**INTEROFFICE MEMORANDUM**

**DATE:** July 30, 1991

**TO:** BRIDGE DIVISION PERSONNEL

**SUBJECT:** Slab Reinforcing Steel

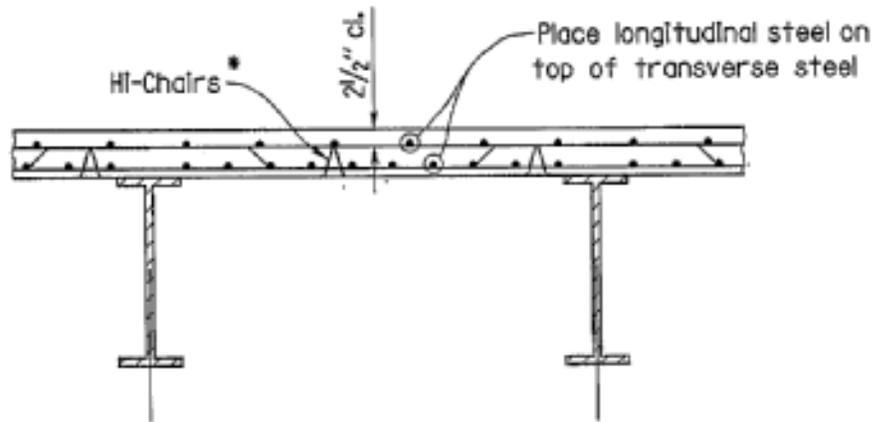
In order to try to reduce the problem of transverse cracking of slabs on beams and girders ↑ all detailing should be in accordance with the attached sketch.

I also need three or four continuous beam type bridges to use as experimental projects. On these projects, with epoxy coated reinforcing steel, I want to use 1-1/2" clear to the longitudinal steel.

\* Place HI-Chairs as far from gallop as is practical

For <sup>GIRDERS</sup> W-BMS, PRESTRESSED CONCRETE BEAMS

Keep HI-Chairs @ 4' Center Under Transverse Bar
